MFN 04-136

Project 717

Subject: **ESBWR Design Changes Since Design Description**

ESBWR Design Changes Since Design Description

Figure 1. ESBWR Core Schematic

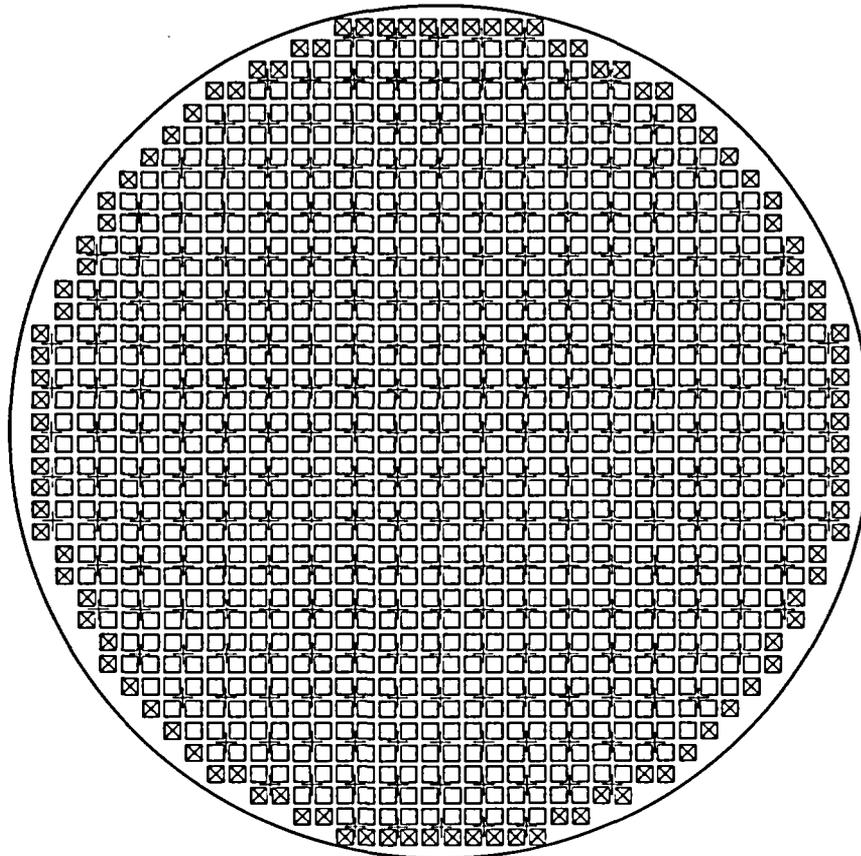
The F Lattice, as described in Section 2.2 of Reference 1, contains a triangular-pitch control rod pattern that controls twelve fuel assemblies using one large control rod and controls each corner of the array by an adjacent control rod. This arrangement will be replaced by the standard BWR square-pitch control blade pattern with one control blade that controls each four-bundle cell. For ESBWR the core lattice type is now described as an N Lattice. The total number of control rod drives increases from 121 to 269 with this lattice change and the core size increase described above in Section 2.1. All reactor internal components that were modified to accommodate the F Lattice, such as the Control Rod Guide Tube, Fuel Support, Core Plate and Top Guide will revert back to the standard BWR designs. The new core and control blade configuration is illustrated in Figure 1.

Figure 2. ESBWR Safety System Configuration (not to scale)

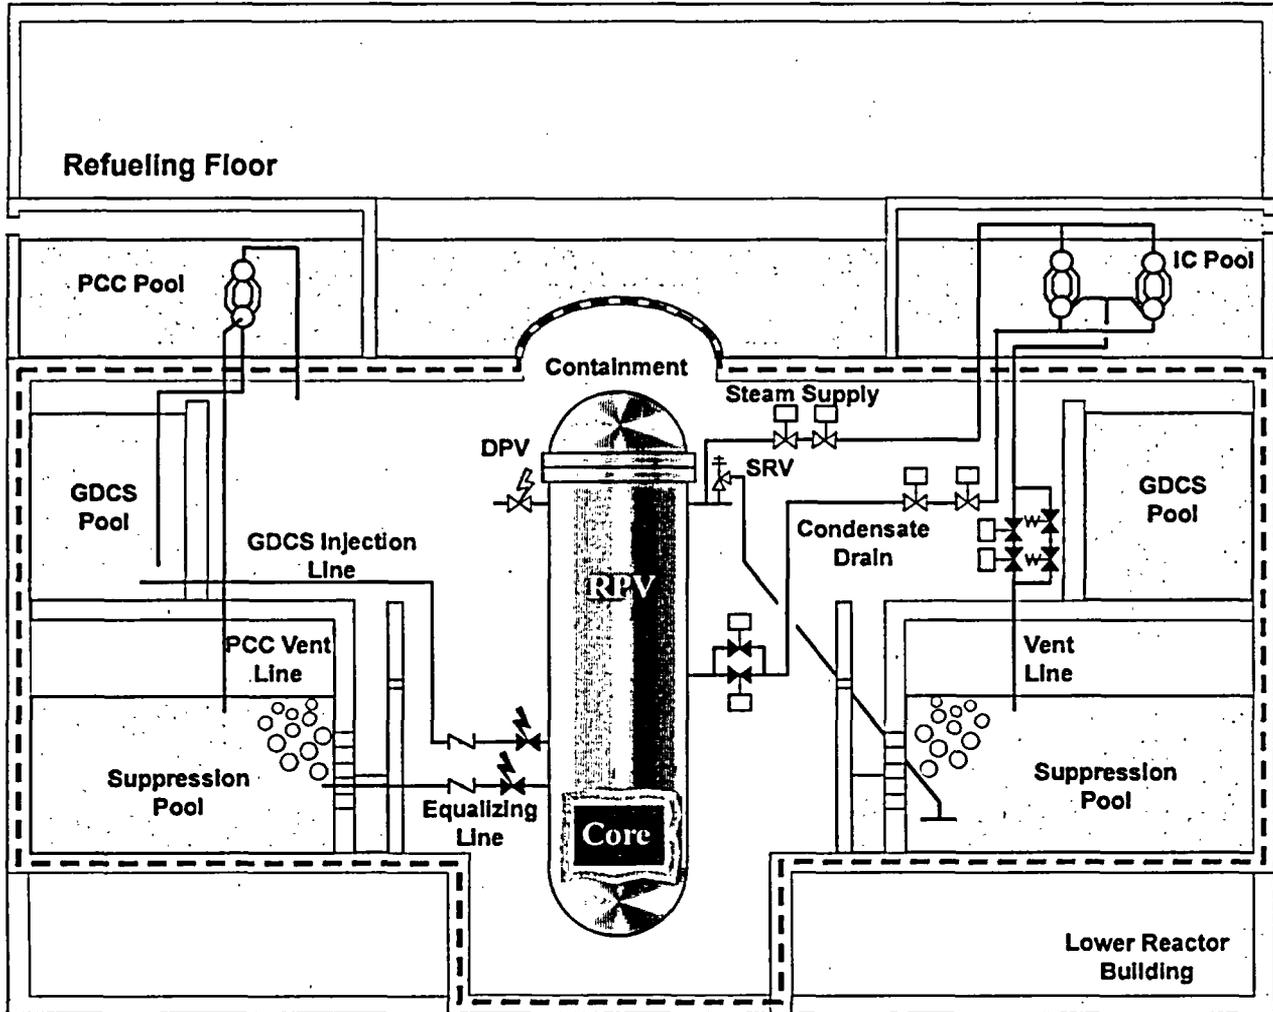
The GDCS pool airspace connections have been moved from the wetwell back to the drywell. Along with this the connecting vent between the wetwell airspace and the GDCS pool airspace has been eliminated (Figure 2). This configuration is the same as the arrangement in the Simplified Boiling Water Reactor (SBWR) design, which makes the configuration the same as in the integral systems test programs – PANDA M and GIRAFFE – used for qualification of the TRACG code. Containment volumes were adjusted along with this change to ensure the resulting wetwell-to-drywell volume ratio retains most of the benefit in reduced containment pressure that was gained when this GDCS airspace volume was originally moved from the drywell to the wetwell. While the previous configuration provided additional efficiency in the containment pressure performance, it resulted in several complicating design issues. This change primarily affects Sections 1.4.2 and 4.1 of Reference 1.
